Drake Coal Project EPBC Approval 2010/5457 – Variation of Condition 14

GROUNDWATER MONITORING AND MANAGEMENT PLAN

Drake Coal 2010- 5457 Groundwater Monitoring and Management Plan

Figure 6-1 Exceedance Investigation, Notification and Reporting Requirements

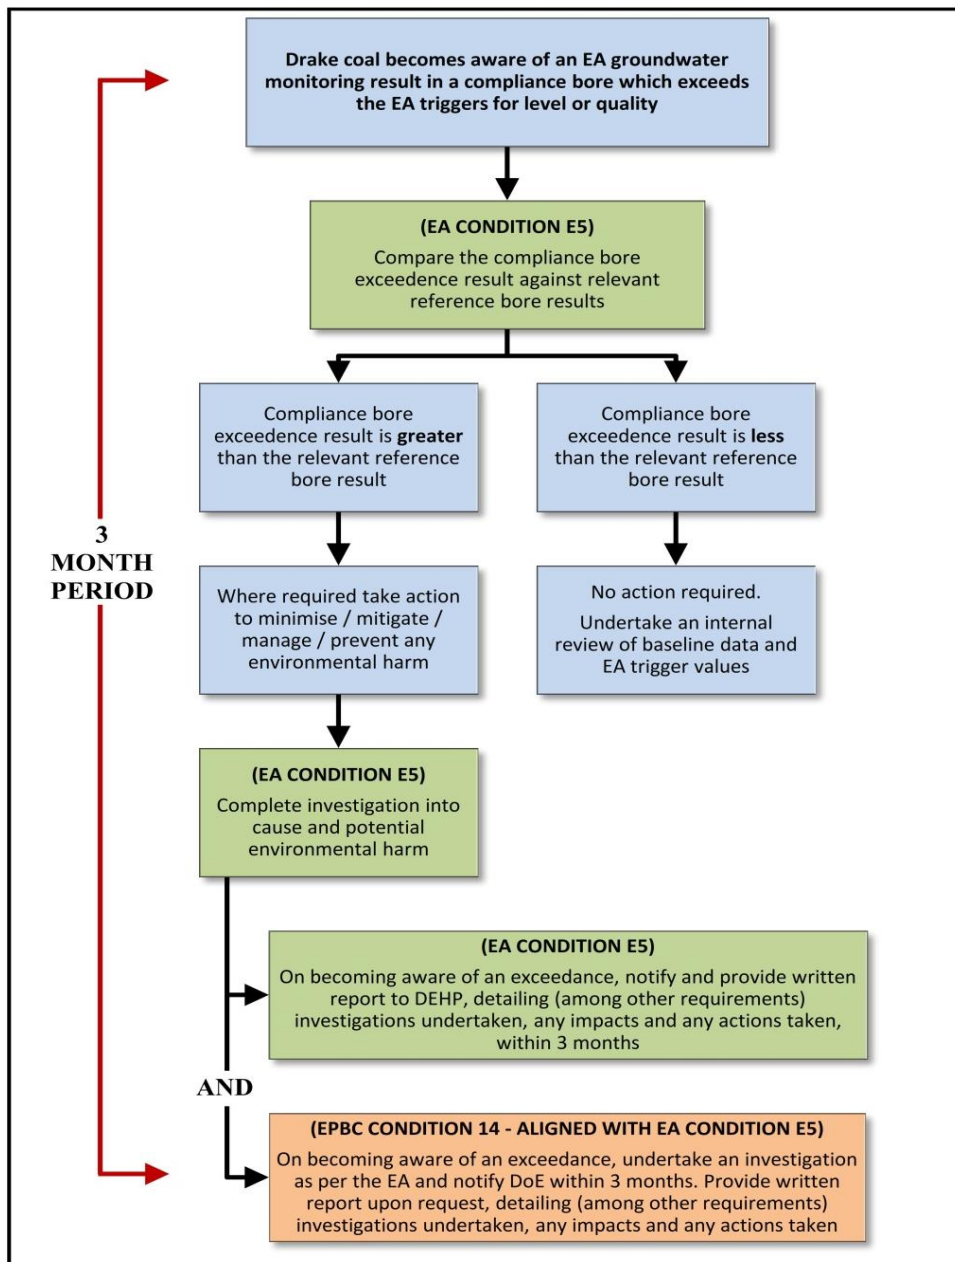
Section 6 of the GMMP includes a flowchart for exceedance investigation, notification and reporting requirements (Figure 6-1). The proposed procedure requires Drake Coal to do the following when it becomes aware of an exceedance:

Conditions requiring an investigation into an exceedance is outlined in section 6.2. Potential actions to minimise impacts and/or prevent further occurrences are included in section 6.3. **This section is very brief. The Department requests further detail on corrective actions where a trigger level is exceeded. This detail may refer to the types of actions discussed in the “Emergency and Contingency Planning” section of the *Drake Coal Project: Environmental Impact Statement – Water Management Plan*.**

Figure 7-2 EIS Analytical Model Results – Drawdown Extent Map

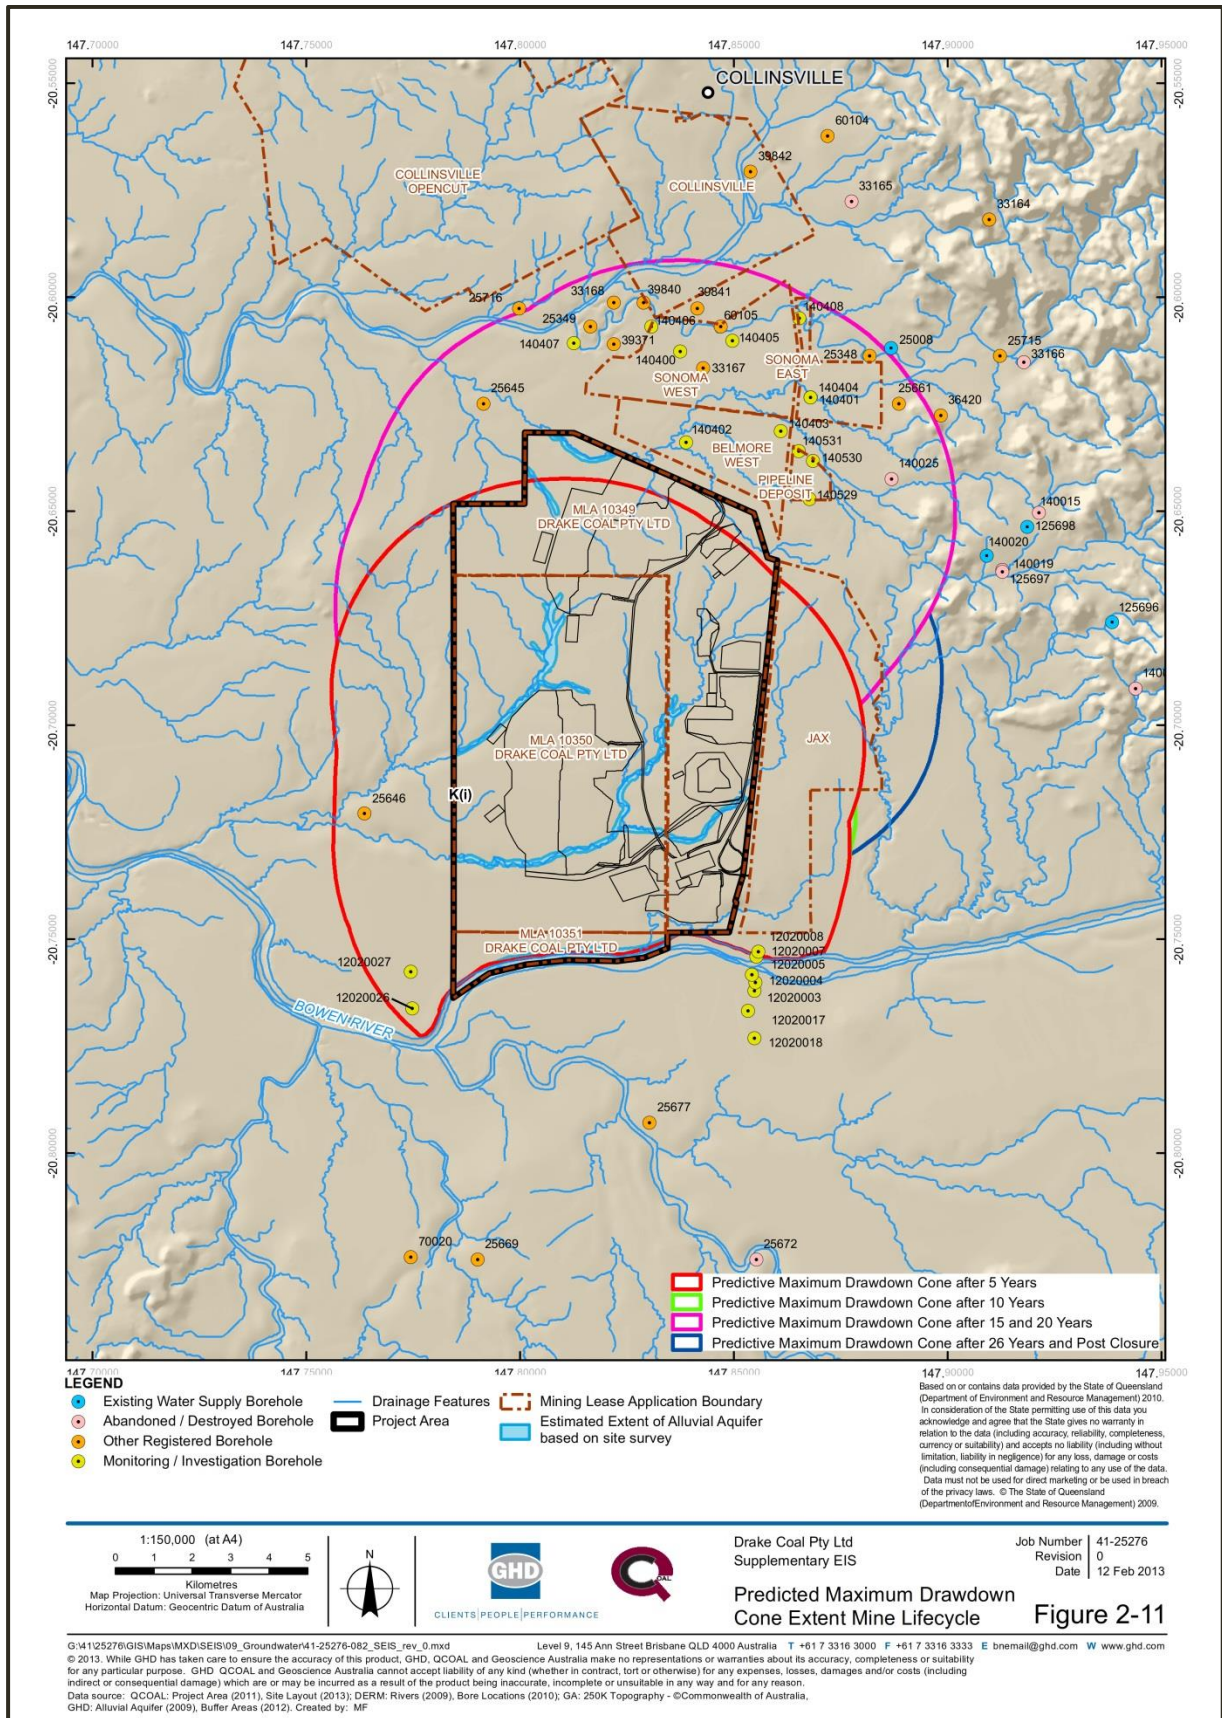
The maximum extent of predicted drawdown from the numerical model does not exceed that maximum predicted drawdown extent from the analytical model undertaken in the EIS (**Figure 7-2**) for either the cover material and
